GRADING AND EROSION CONTROL PLAN

JUDGE ORR ROAD RV PARK AND STORAGE

EL PASO COUNTY, COLORADO

PCD PROJECT NO. PPR-16-040

DRAINAGE, GRADING & EROSION CONTROL PLAN

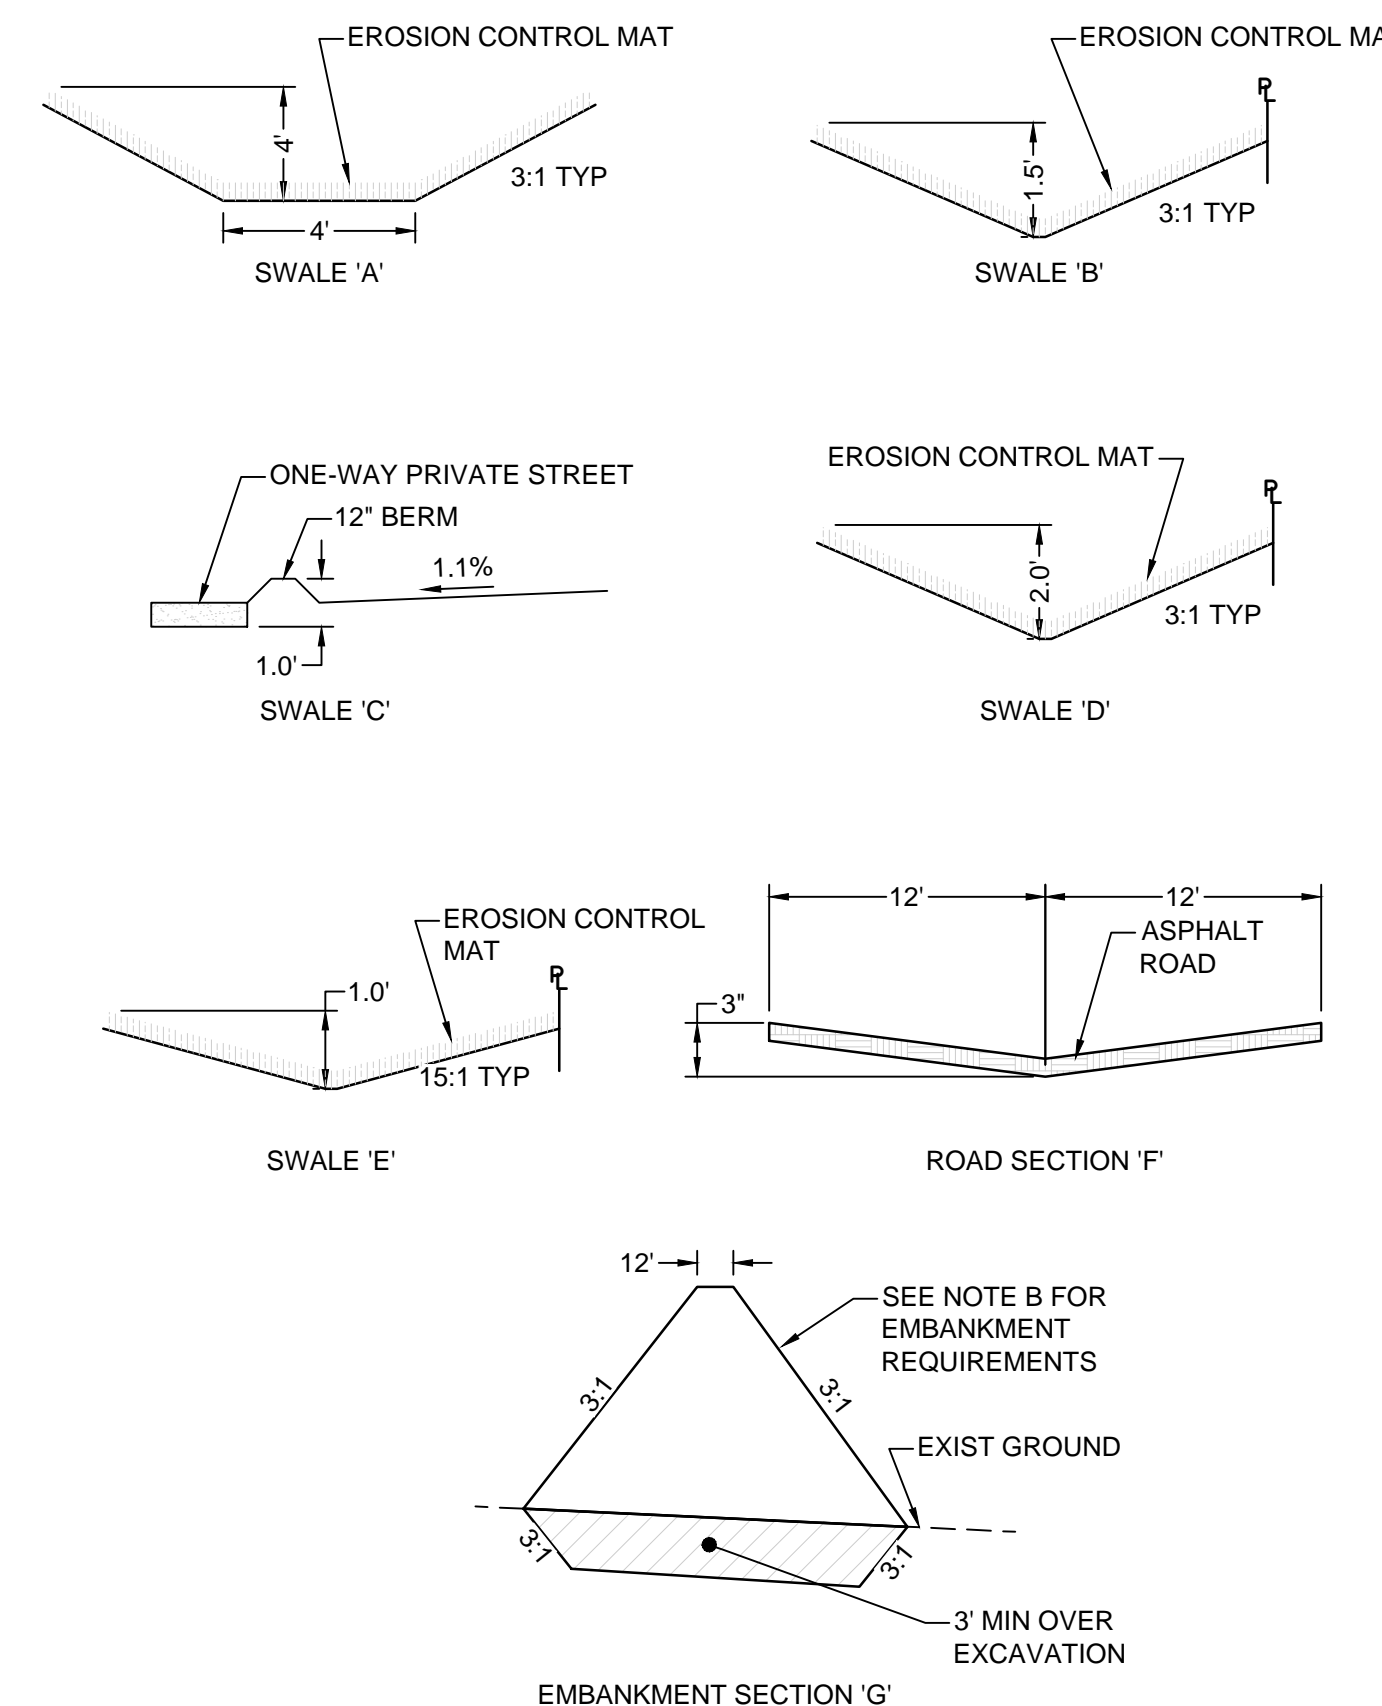
Reliable if this is supposed to be swale E.
Per the drainage report the Froude number is greater than 0.90. Grass lined channel is not sufficient.

SECTION D
NTS

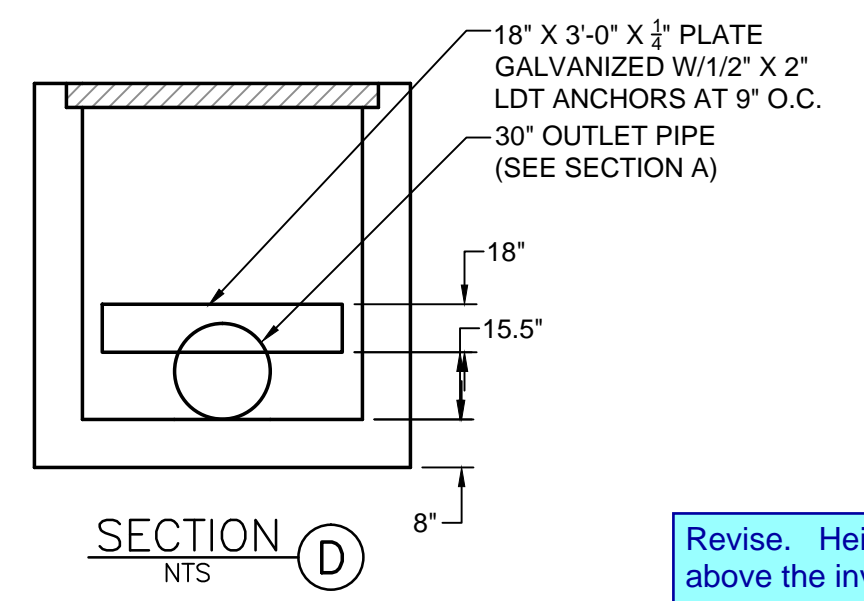
Revise. Depth of pipe invert does not match the drainage report.

SECTION A
NTS

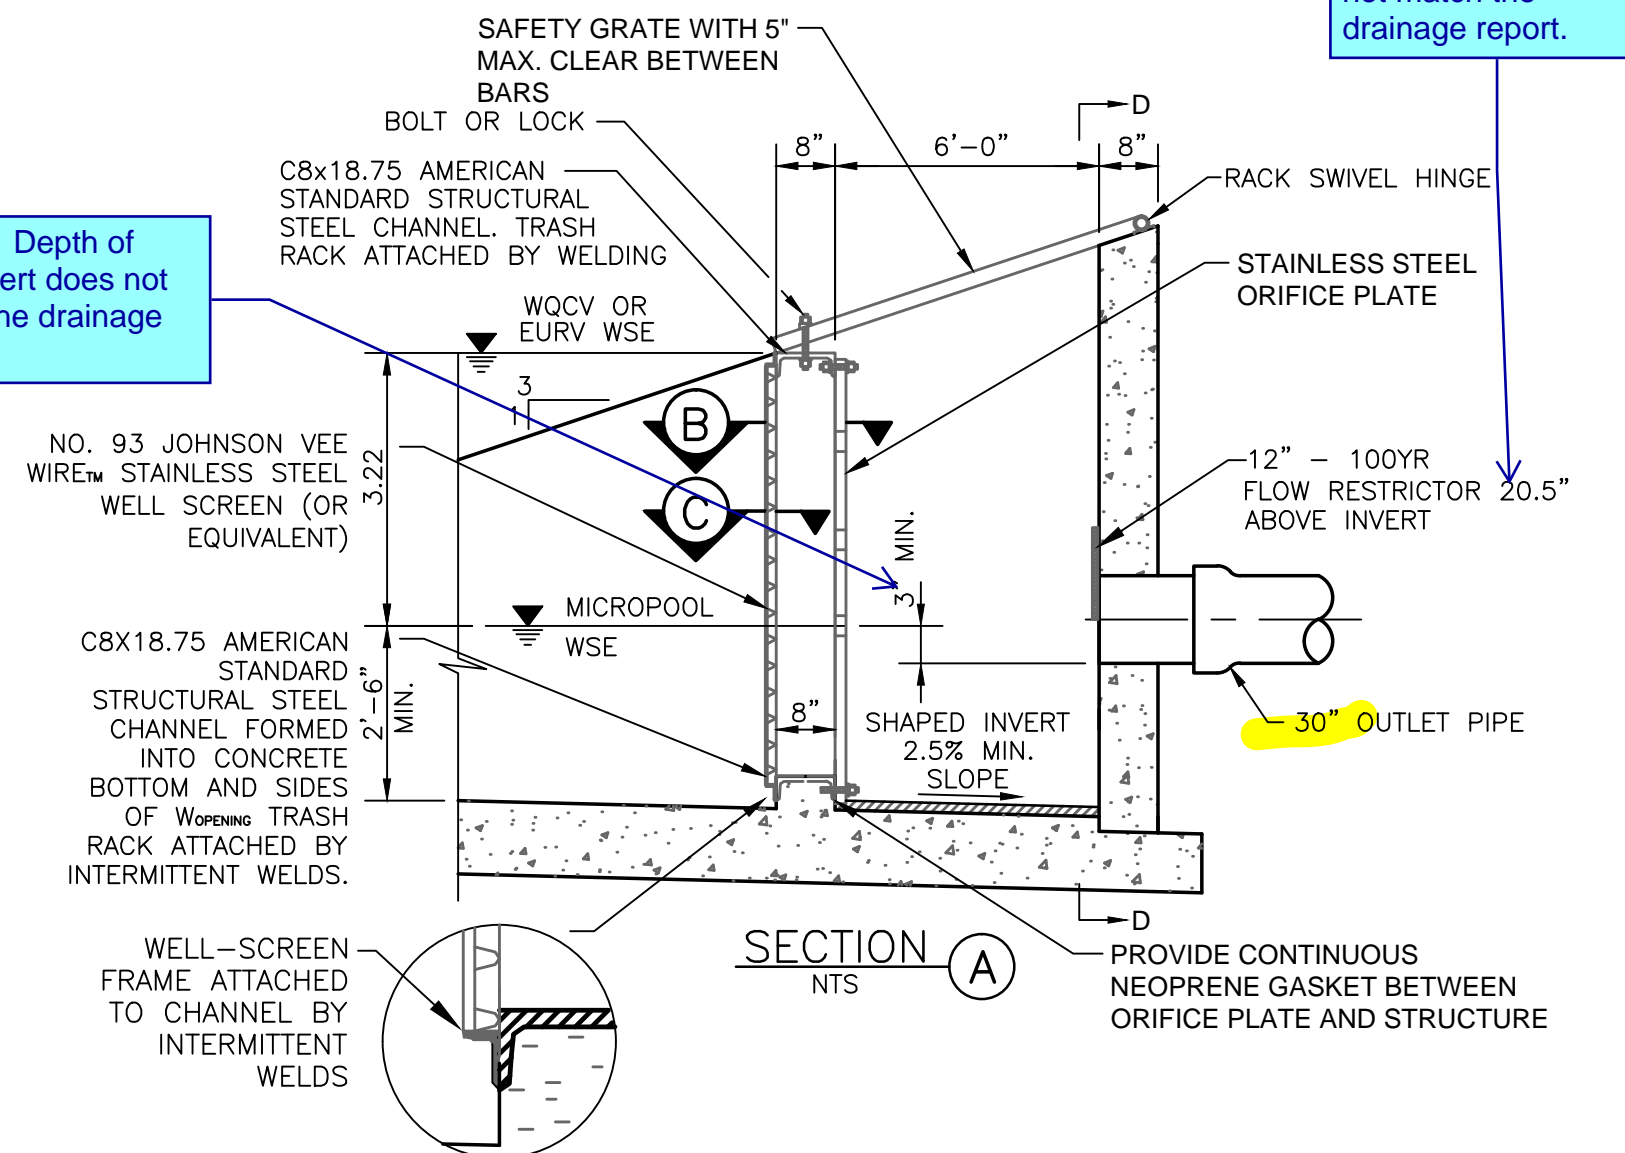
Revise. Height above the invert does not match the drainage report.

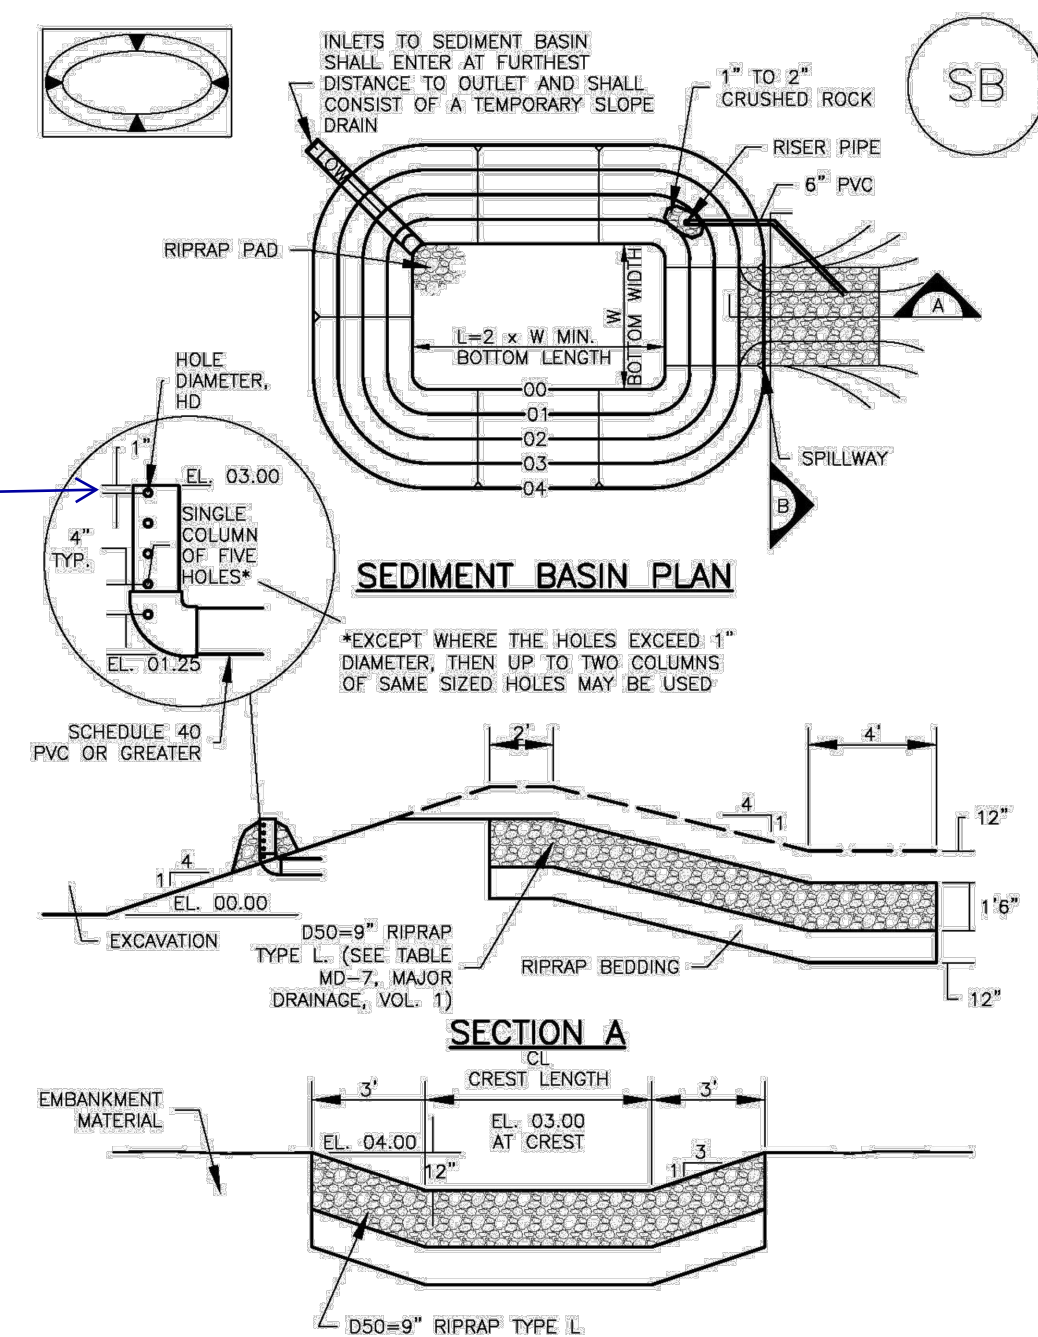
Identify the specific construction requirements for the riser pipe (hole diameter and riser pipe height, diameter, etc) and not rely on the general contractor to interpret Table SB-1 correctly. Table SB-1 is for standard basins which does not seem to apply to the pond configuration shown on the grading plan.

36" HDPE STORM SEWER PROFILE
 SCALES HORIZONTAL 1"=60' VERTICAL 1"=10'

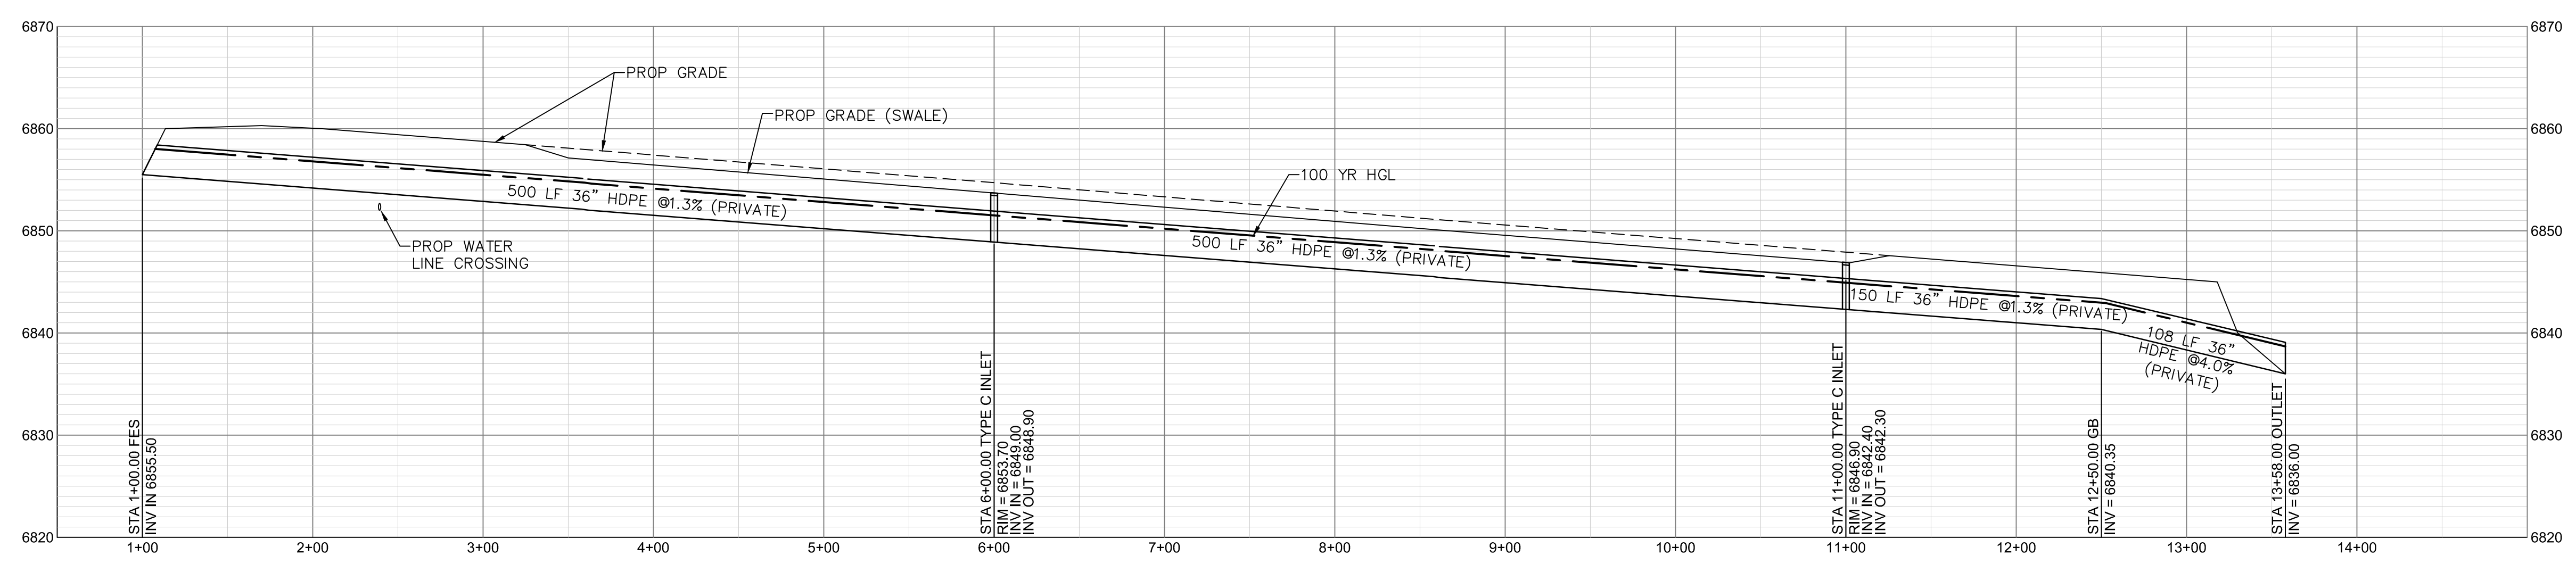
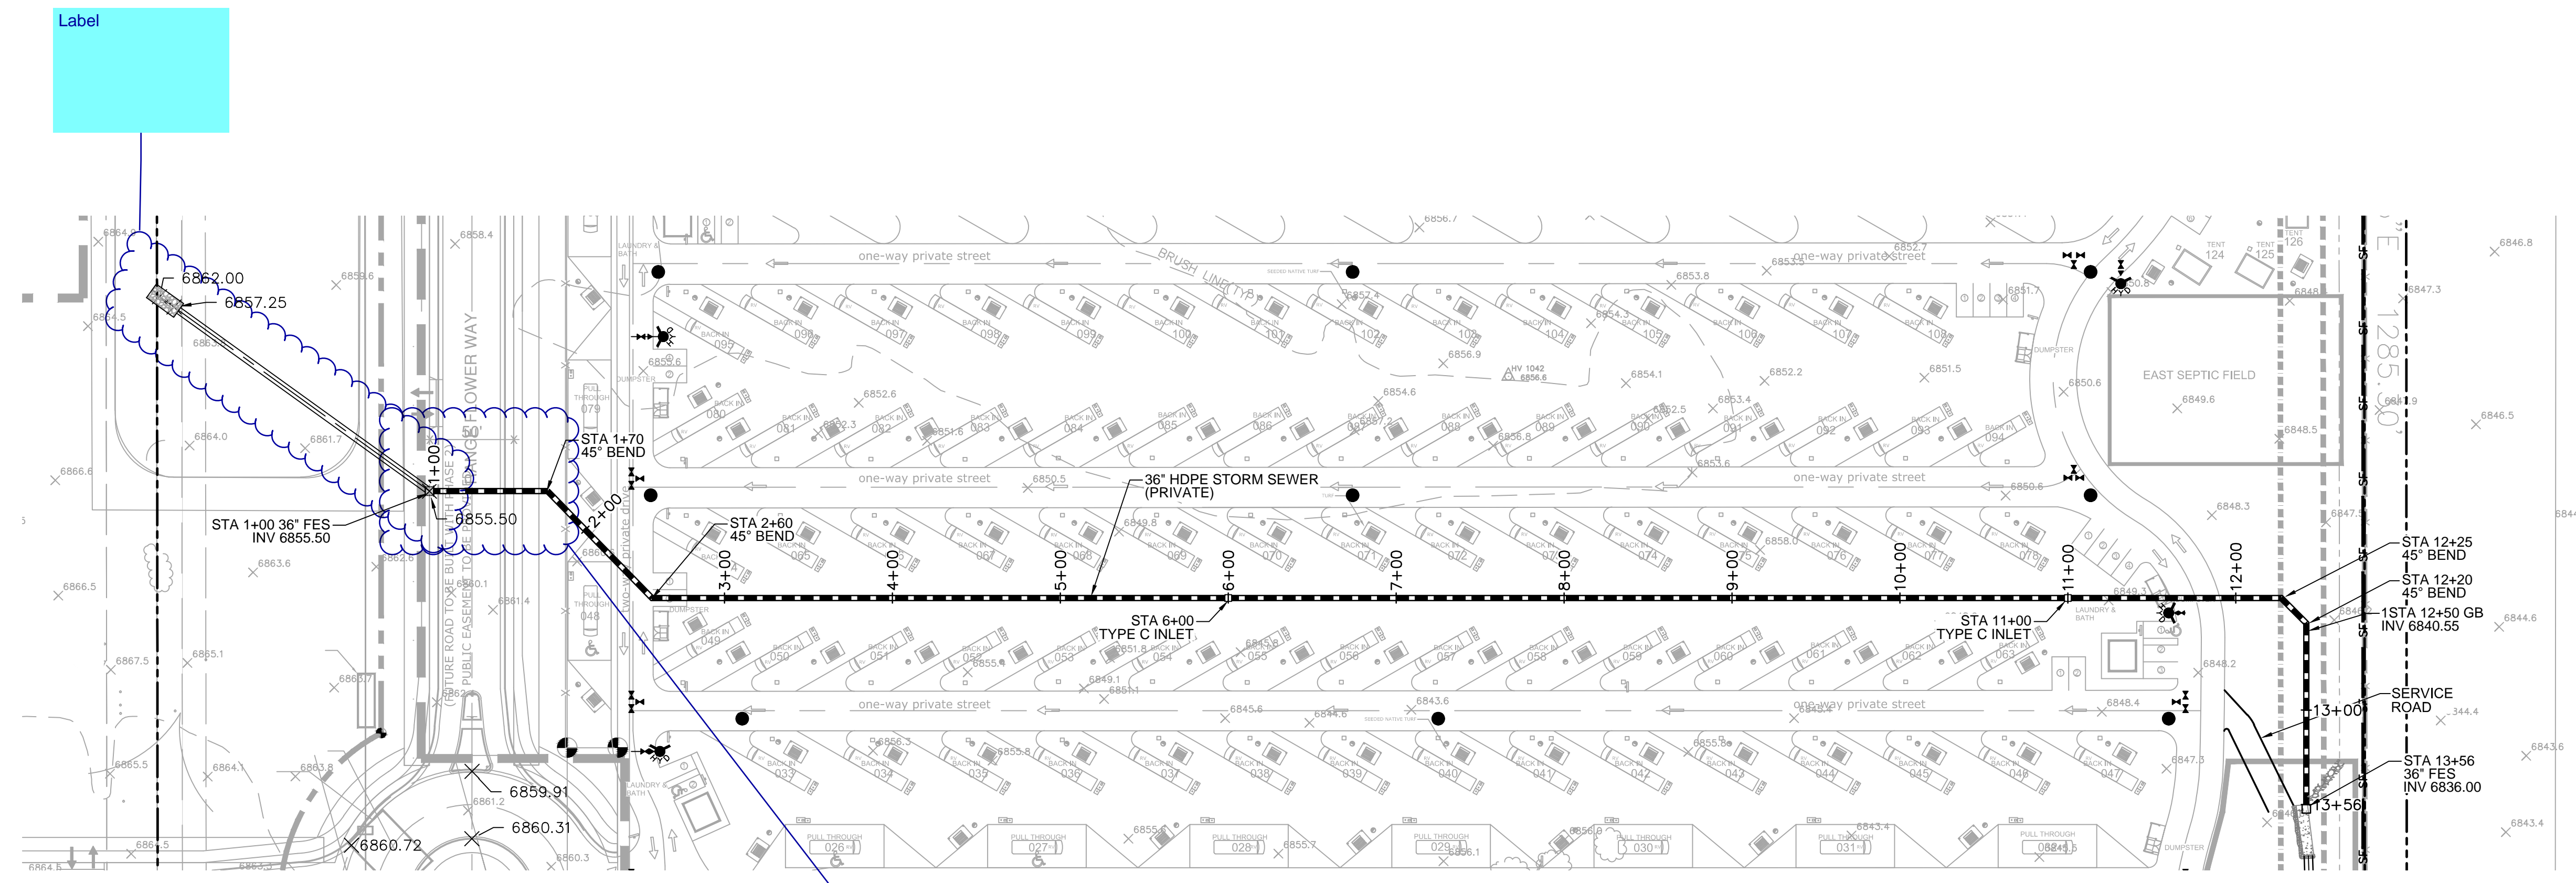
Identify the specific construction requirements for the riser pipe (hole diameter and riser pipe height, diameter, etc) and not rely on the general contractor to interpret Table SB-1 correctly. Table SB-1 is for standard basins which does not seem to apply to the pond configuration shown on the grading plan.

Revise. Height above the invert does not match the drainage report.

Revise. Depth of pipe invert does not match the drainage report

If the road is planned to be dedicated to the County then revise the pipe within the anticipated future ROW to be RCP. Per ECM 3.3.1.J.1 All storm sewers within the County's ROW are required to be RCP (min Class 3, Wall B)
